Answers to Sept 11 Questions

- 1. Descope/upscope items - please provide both preferred/scheduled and need-by dates...

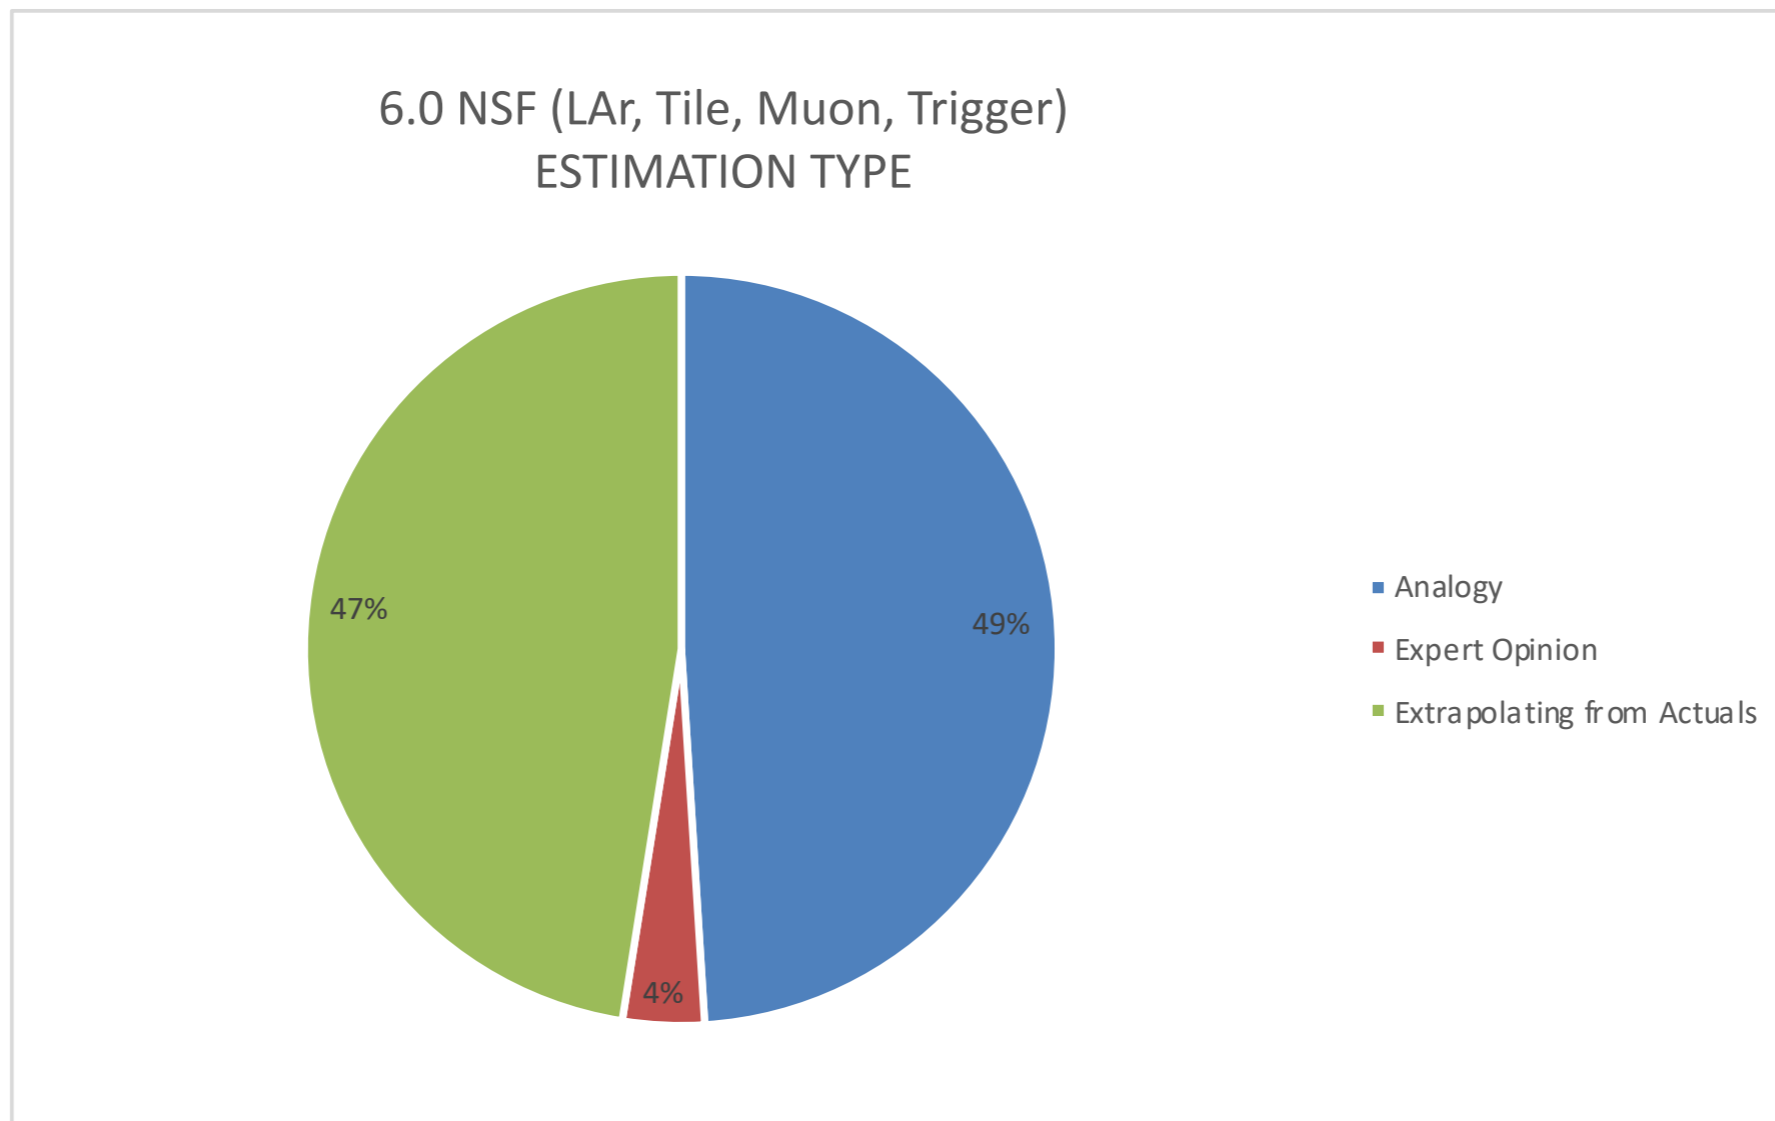
- 3. Provide top 5 risks in rank order (worst->least) for each major subsystem.
 - Tile:
 - Cost scores for Tile all at 1(Low); Schedule score up to 3(Med)
 - Reasonable responses for all
 - RN-06-05-04-005: (120) delay in receiving LV box parts from collaborator
 - RN-06-05-03-003: (90) ELMBMB production yield lower than expected
 - RN-06-05-01-003: (60) radiation certified MB component no longer avail.
 - RN-06-05-04-001: (60) LV brick redesign due to unavailable component
 - RN-06-05-03-001: (60) ELMB2 potential delays due to CERN board production
